DAUPHIN COUNTY SUBDIVISION/LAND DEVELOPMENT REVIEW REPORT

Municipality	West Hanover & East Hanover Township		Surveyor	James C. Hockenberry, P.L.S.		Engineer	Williams Site Civil LLC	
Plat Title	Preliminary Major Subdivision & Land Development Plans-Oakvale Planned Community							
Zoning District	Commercial Mixed Use (CMU)				Proposed Land Use	Residential - townhouses		
Plat Status:	<u>X</u>	Preliminary	Plat Type:	<u> </u>	Subdivision	Regulations:	<u> </u>	County
	<u> </u>	Final		<u> </u>	Land Development		<u>X</u>	Municipal
	<u> </u>	P/F		<u>X</u>	Combined		<u>X</u>	Zoning
	<u> </u>	Minor		<u> </u>			<u>X</u>	S&LD
# of Lots	<u>9</u>	# of New Lots	<u>1</u>	# of DUs	<u>253</u>	Acs Subdiv/Devel	S-45.29; D-33.18	Total Acs <u>45.29</u>
Date Received	<u>8/8/2025</u>		Staff Review	<u>8/14/25</u>		Official County Review	<u>8/14/25</u>

Project Description: To obtain preliminary approvals for the subdivision and land development of a 253-unit residential planned community.

Plan No. 25-087

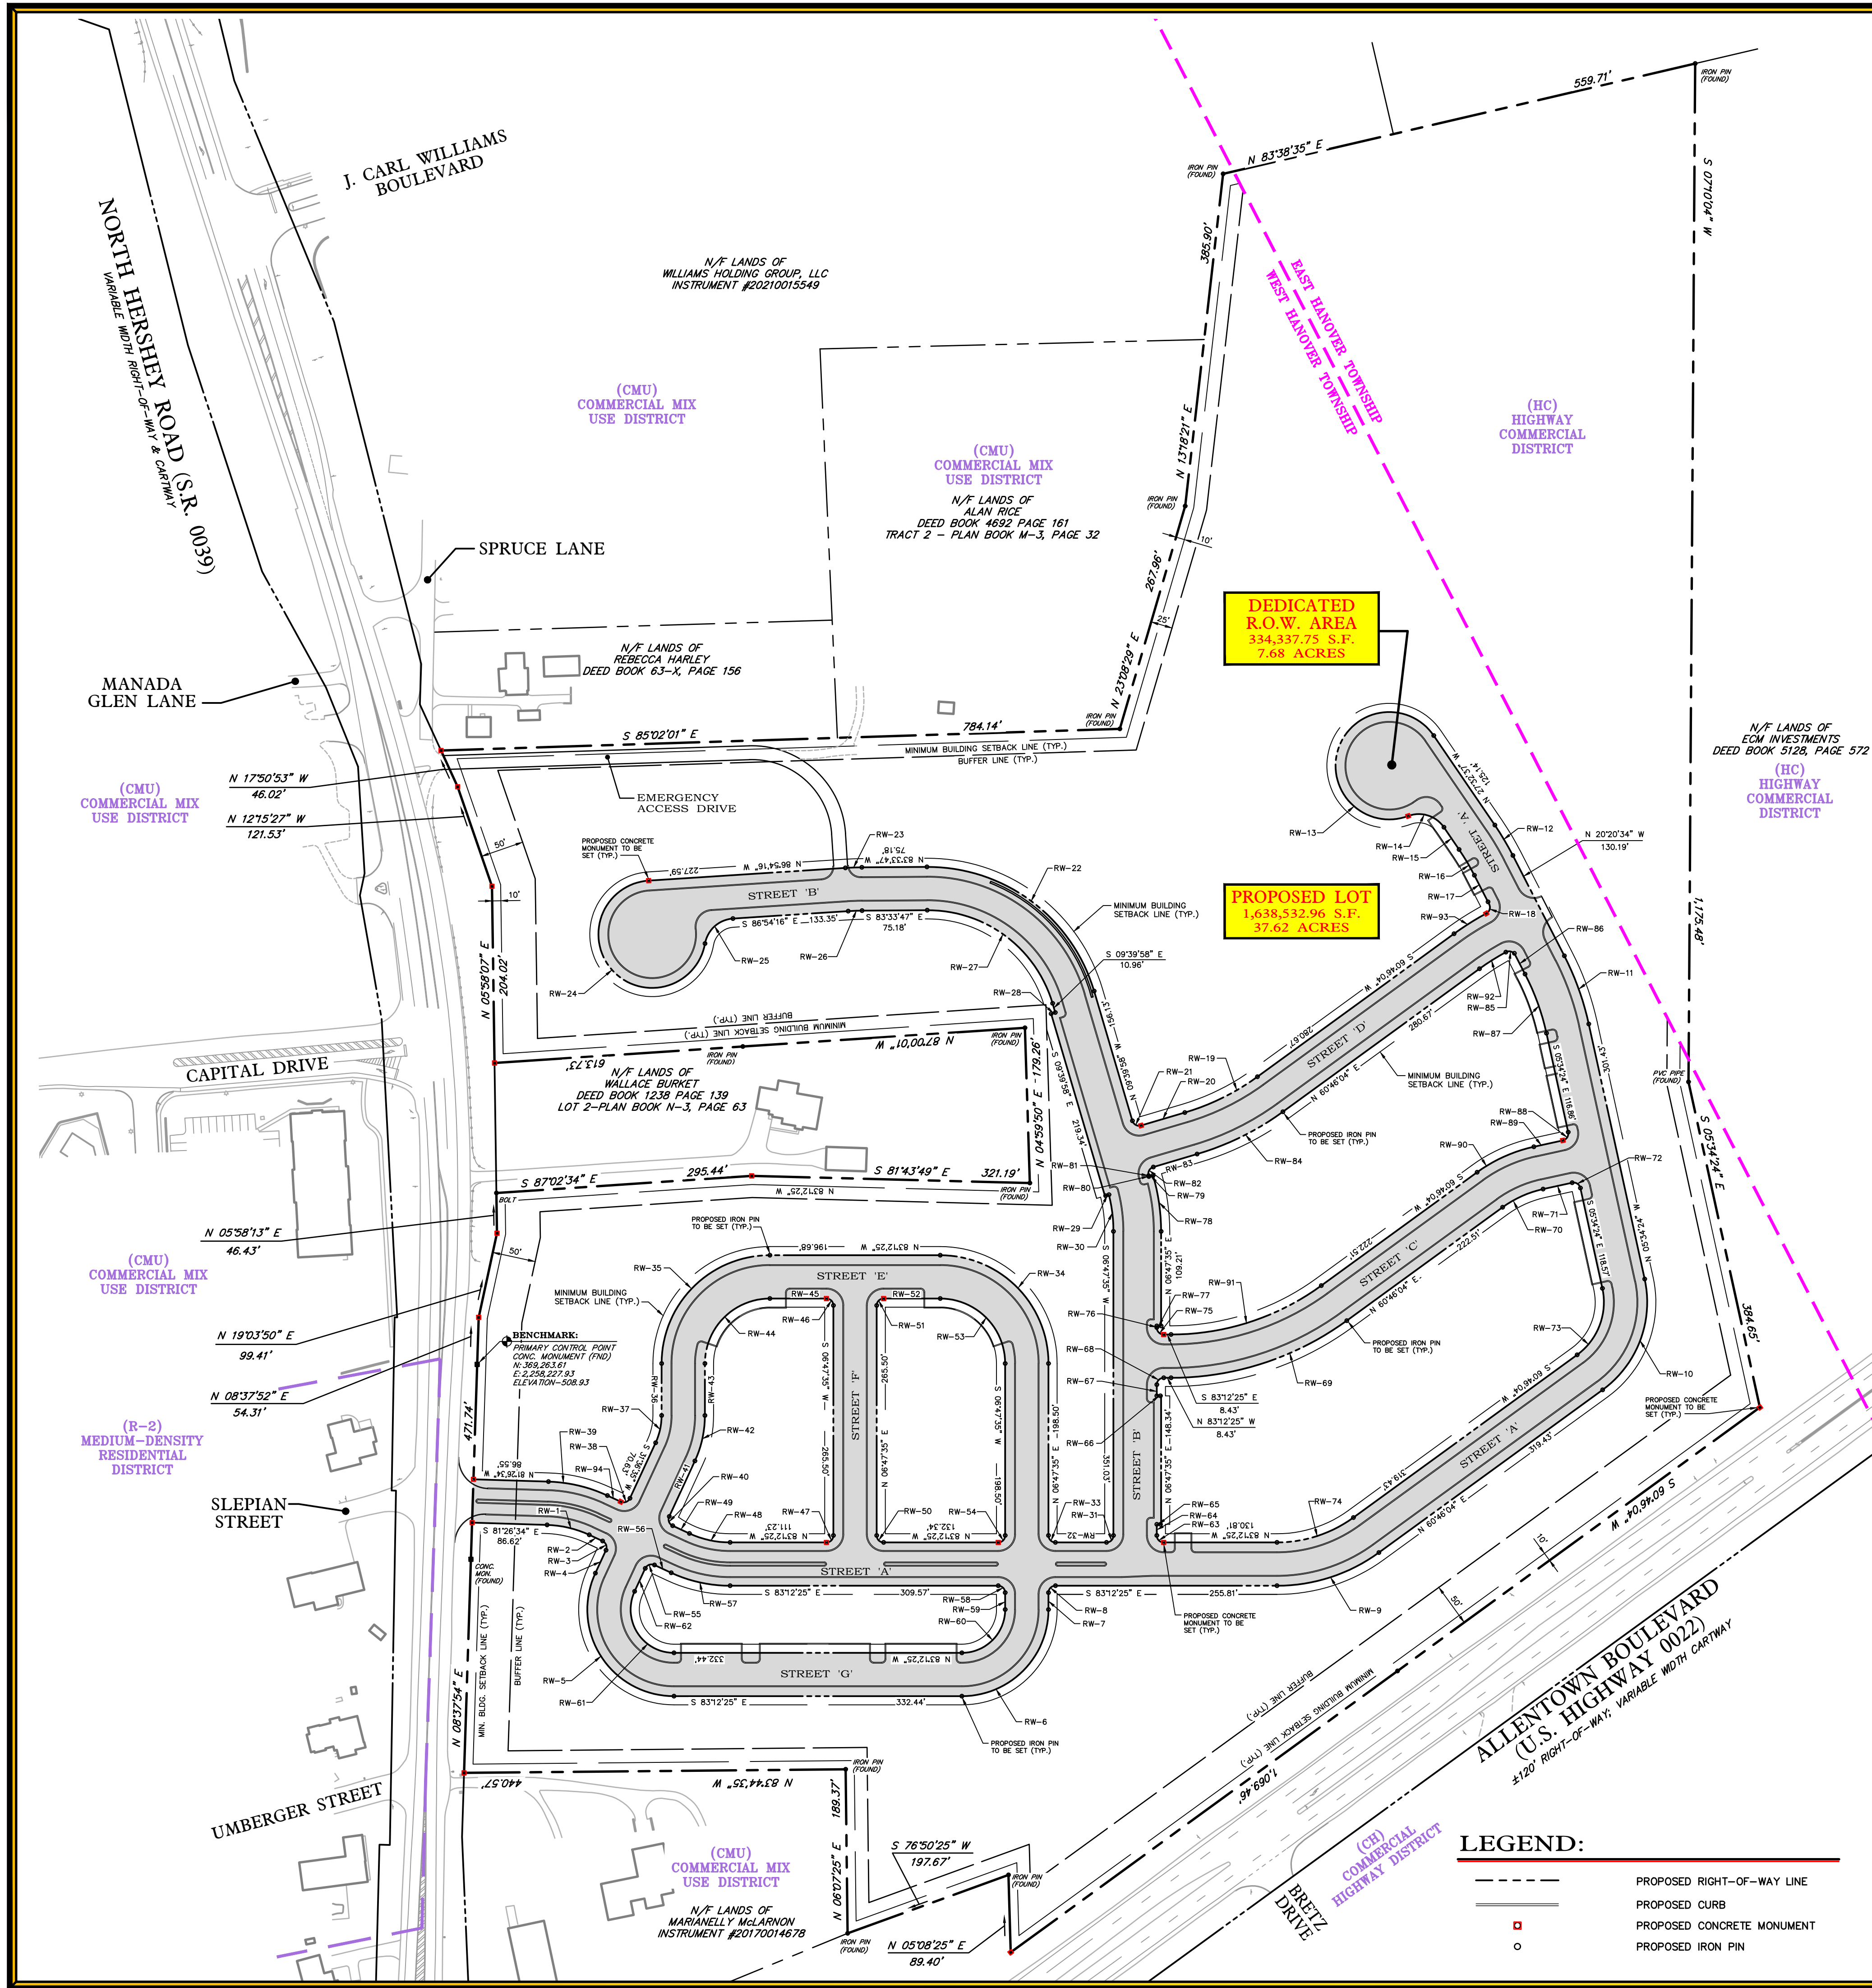
1. Discrepancy between LC-1, SUB-1, (and developed land acreage on application submitted to the County) of proposed lot acreage
 - a. Also, show lot areas of each parcel pre-Subdivision?
2. Depict (in more detail) ROW and Paving Widths of Allentown Boulevard (US Highway 22) and North Hershey Rd. (SR 39).
3. For a development of this size, will a single access point (along with an emergency access drive) be enough to provide proper access?
 - a. Specifically, in relation to peak traffic hours and emergency management services.
4. In this instance, is the cul-de-sac included on the plan a practical addition to the development's street system (S&LDO §173-25-G-2-a)
 - a. Is the cul-de-sac designed to adequately maneuver emergency vehicles, maintenance vehicles, school buses, and moving van vehicles? (S&LDO §173-25-G-2-d)
